## Responses to Comments from Downtown LA Arts District Business Improvement District, Lopez, Estela

RE: Metro Public Comment  
**Future 5<sup>th</sup> & Flower Station - Preclusion avoidance**

## Responses to Comments from Weisenhaus Architecture, Weisenhaus, Duane

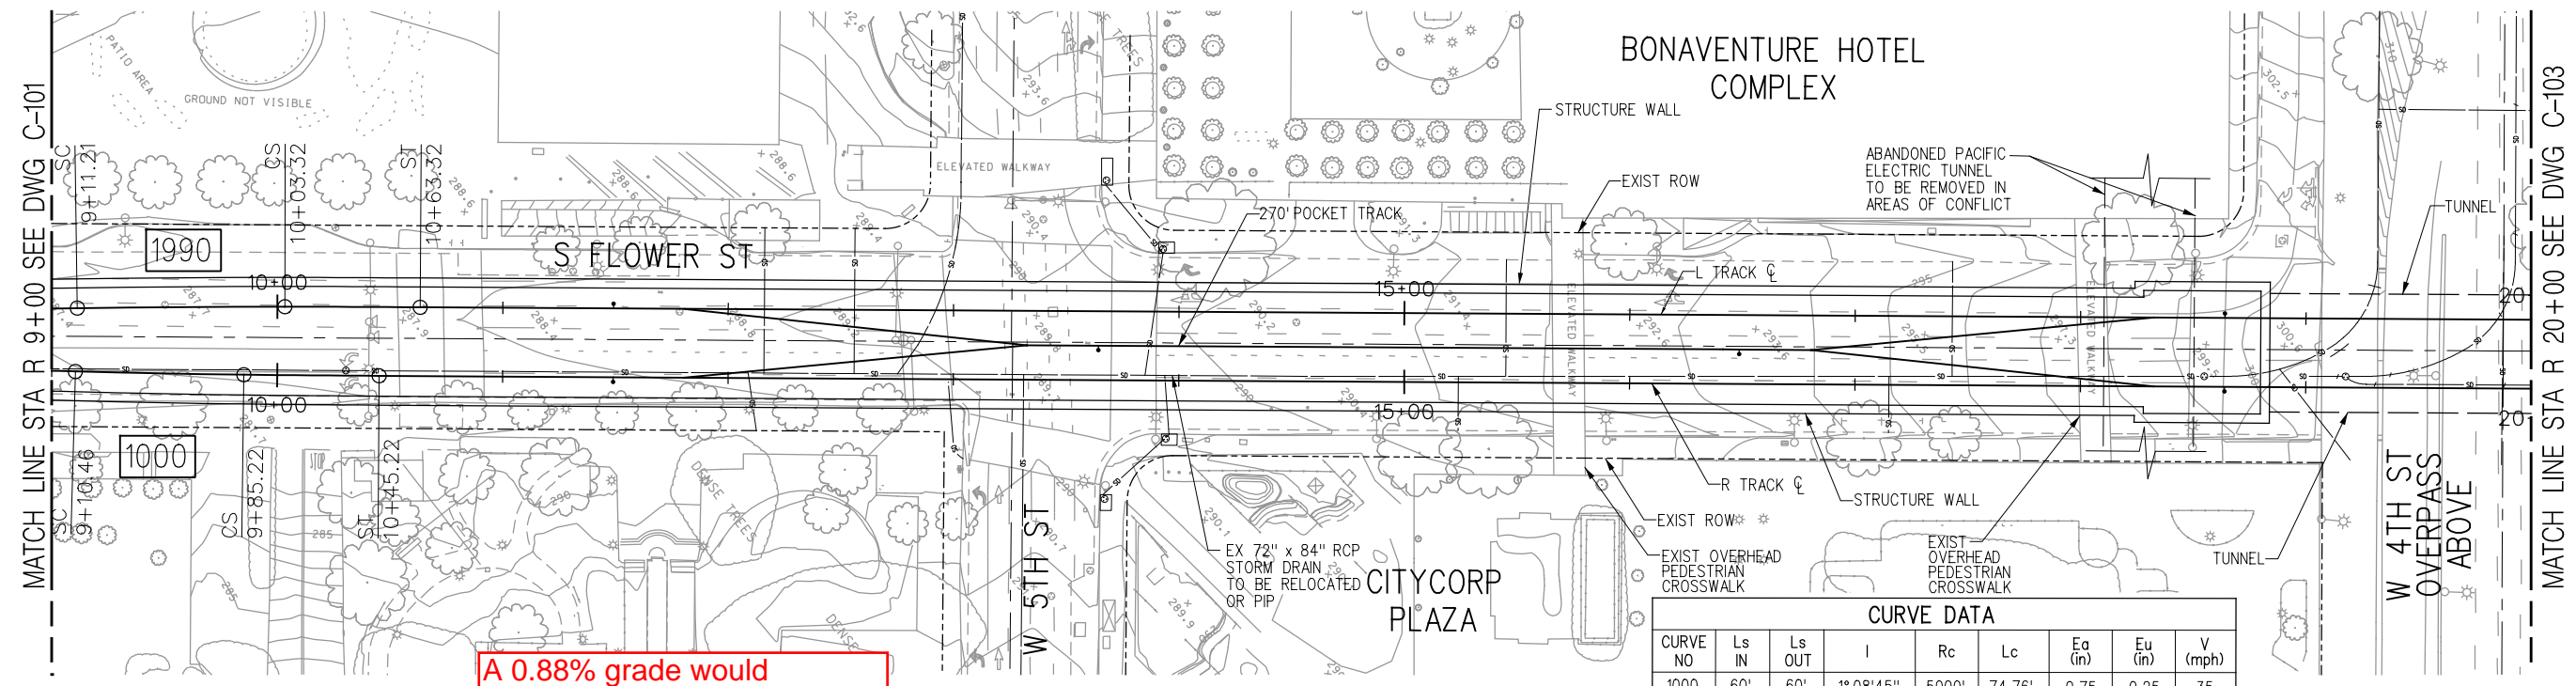
**However, there are two design items indicated in the Supplemental DEIS/R that would preclude a future 5<sup>th</sup> & Flower Station:**

1. The location of a substation between 5<sup>th</sup> & 4<sup>th</sup> Streets. Per DEIS/R, Chapter 2.0, page 2-2: A traction power substation (TPSS) would be located along Flower Street between 5<sup>th</sup> and 4<sup>th</sup> Streets in the deleted Flower/5<sup>th</sup>/4<sup>th</sup> Street station location"
2. A sloped grade between 5<sup>th</sup> & 4<sup>th</sup> & Streets. Per DEIS/R, Appendix R-1, Engineering drawing C-102, an 0.88% grade is indicated, in lieu of the 0.00% grade indicated on the DEIS/R drawings released in August 2010.

Would preclude a future 5th/Flower Station

- The now deleted 5<sup>th</sup> and Flower station site developed during the Draft EIS/EIR included a traction power substation (TPSS) and the area needed for a TPSS site. Although the station has been deleted, the TPSS can still be located at the site/space it had been previously identified for without encroaching into the area that was previously identified in the Draft EIS/EIR for the 5<sup>th</sup> and Flower station. Therefore, the TPSS would not preclude the building of the 5<sup>th</sup> and Flower Station in the future because adequate space underground would still be available.
- Metro's design criteria for maximum slopes at station platforms is one percent. The slope identified is less than one percent; therefore, the slope grade between 5<sup>th</sup> and 4<sup>th</sup> Street is suitable for a station in the future.

**REGIONAL CONNECTOR TRANSIT CORRIDOR**  
**ADVANCED CONCEPTUAL ENGINEERING**  
 TRACK ALIGNMENT  
 PLAN AND PROFILE  
 STA R 9+00 TO STA R 20+00

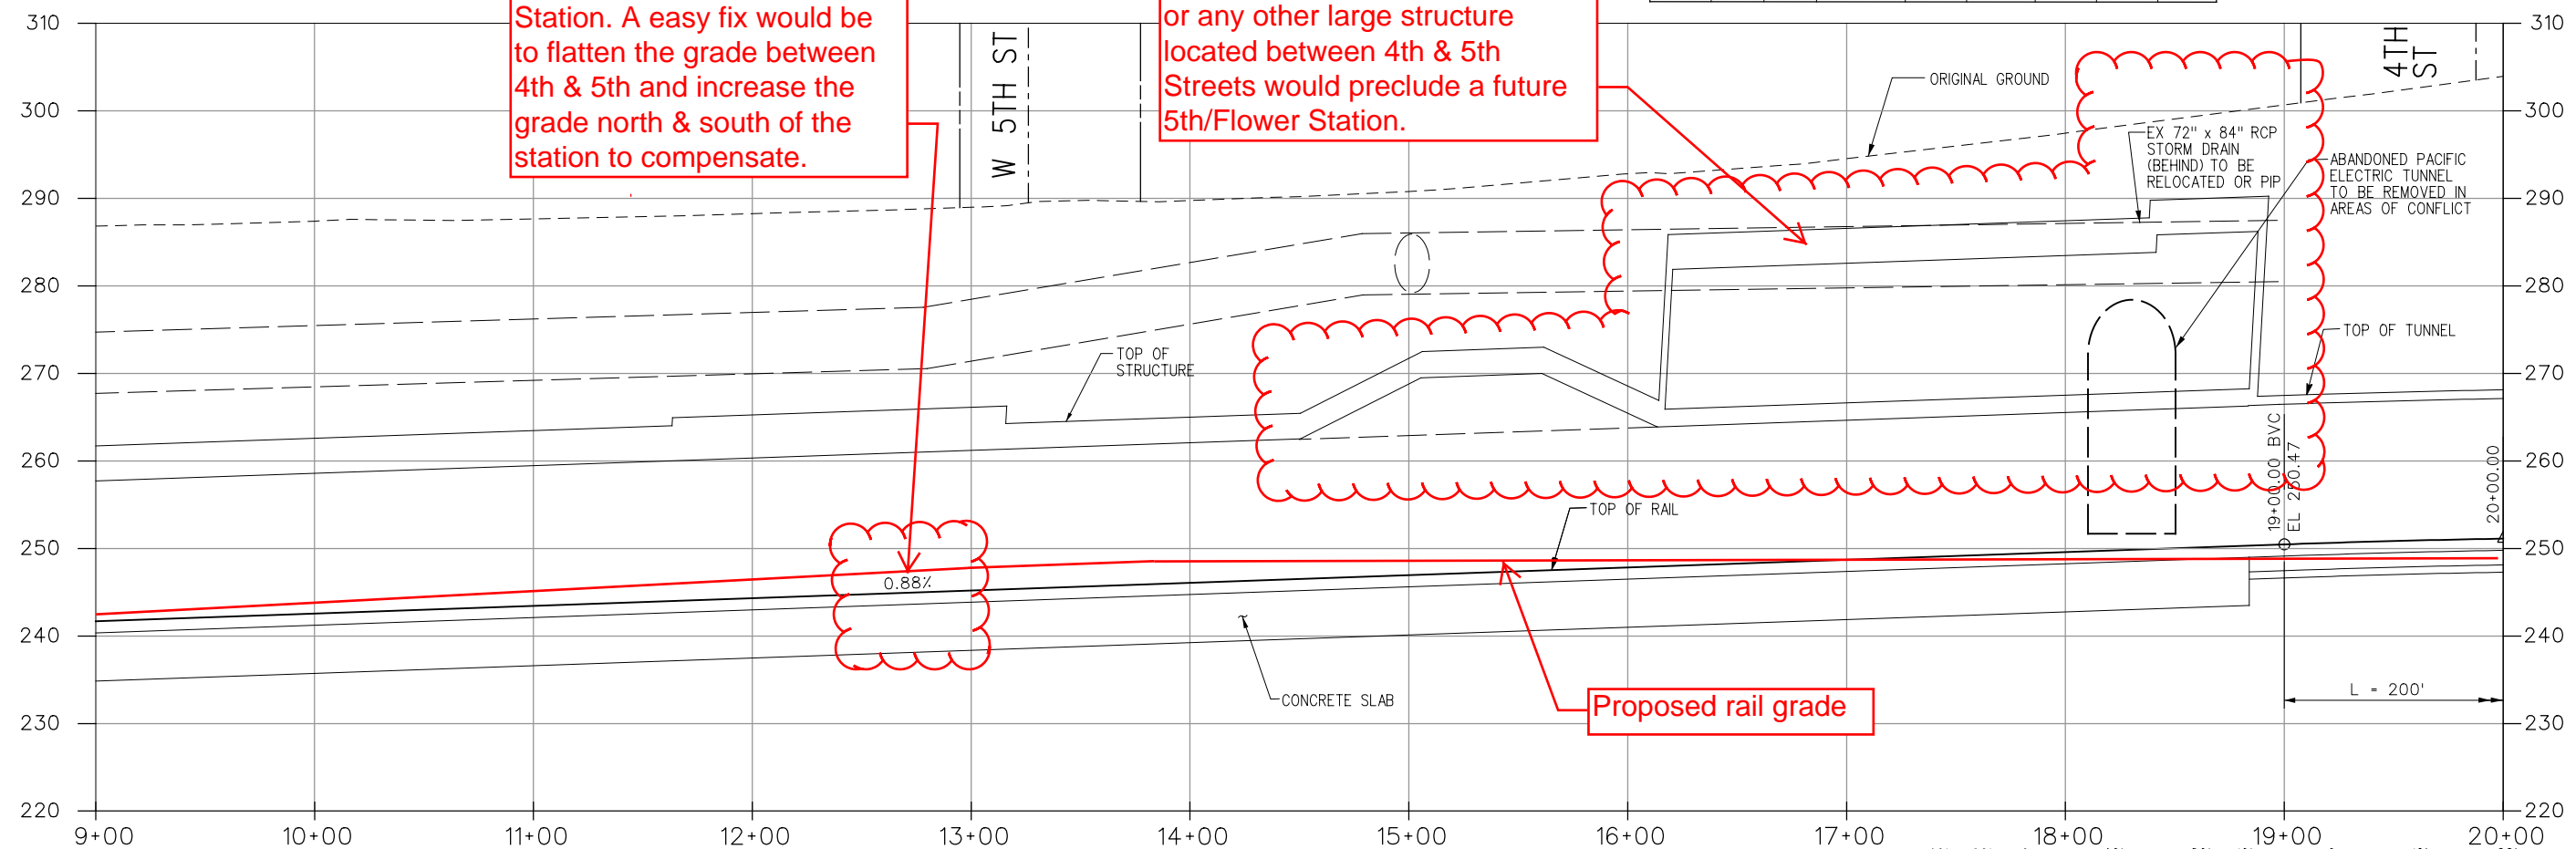
A 0.88% grade would preclude a future 5th/Flower Station. A easy fix would be to flatten the grade between 4th & 5th and increase the grade north & south of the station to compensate.

A traction power station (TPSS) or any other large structure located between 4th & 5th Streets would preclude a future 5th/Flower Station.

The Metro Board of Directors voted on October 28, 2010 to designate the Fully Underground LRT Alternative, without the Flower/5<sup>th</sup>/4<sup>th</sup> Street station, as the Locally Preferred Alternative. The Flower/5<sup>th</sup>/4<sup>th</sup> Street station was excluded from the Regional Connector project as a means of lowering costs. The Locally Preferred Alternative would be constructed so as not to preclude addition of a Flower/5<sup>th</sup>/4<sup>th</sup> Street station at a later time as a separate future project.
